Access Compliance Report

Public Rights-of-Way

Intersection ID: 28372	Main Street: CONSTITUTION_HALL_DR	Cross Street: HIGHLANDS_CROSSING_DR	Location: NE
ADA ID: ED1EF332FCA0	Ramp Type: PerpDiag	Initial Pass/Fail: Pass	Overall Compliance: No
Severity Score: 40			
Codes/Mitigation Info/Possible Solution		Field Measurements/Component Compliance

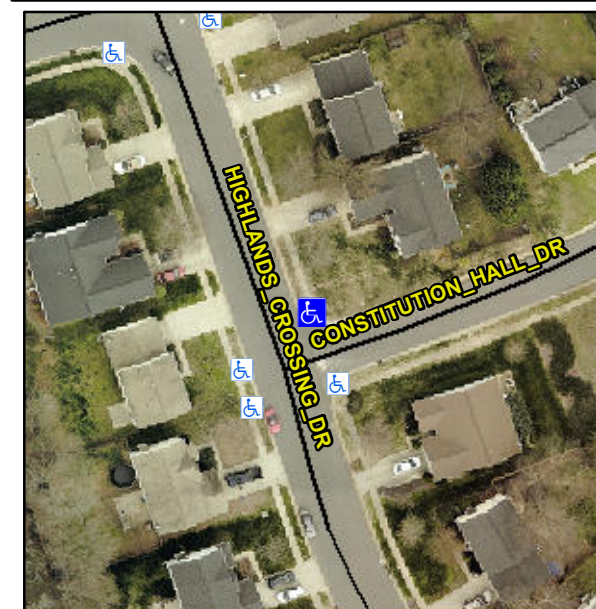
Not Found, R304.2.1, R304.2.2-Perp, R304.3.2-Para, R304.5.3, R305, R302.7.2, R304.5.4

Compliance	Description	Data	Compliance	Description	Data
N/A	Ramp Length (in)	92.0	Yes	Ramp Slope (%)	7.3
Yes	Ramp Width (in)	48.0	Yes	Ramp XSlope (%)	2.0
N/A	Flare Type LT	Sloped	N/A	Flare Type RT	N/A
N/A	Flare Slope LT (%)	5.8	N/A	Flare Slope RT (%)	9.9
N/A	Flare Traversable LT?	Yes	N/A	Flare Traversable RT?	No
No	Landing Length (in)	N/A	No	DWS Provided?	No
No	Landing Width (in)	N/A	N/A	DWS Contrast?	No
No	Landing Slope (%)	N/A	N/A	DWS Length (in)	N/A
No	Landing X Slope (%)	N/A	N/A	DWS Full Width?	No
N/A	Landing Curb? (Y/N)	No	N/A	DWS Offset (in)	N/A
N/A	Shared Landing?	No			
Yes	Gutter Ponding?	No	No	Gutter Slope (%)	9.4
No	Gutter Lip Ht (in)	1.0	Yes	Gutter X Slope (%)	0.3
N/A	Painted X Walk1?	No	N/A	Painted X Walk2?	No
	X Walk 1 Direction	To SW		X Walk 2 Direction	To SE
N/A	X Walk 1 Width (in)	N/A	N/A	X Walk 2 Width (in)	N/A
	X Walk 1 Slope (%)	1.7		X Walk 2 Slope (%)	0.5
	X Walk 1 X Slope (%)	1.6		X Walk 2 X Slope (%)	2.4

Remove & Replace Curb Ramp With Two New Directional Ramps or Equivalent. Remove & Replace Gutter.
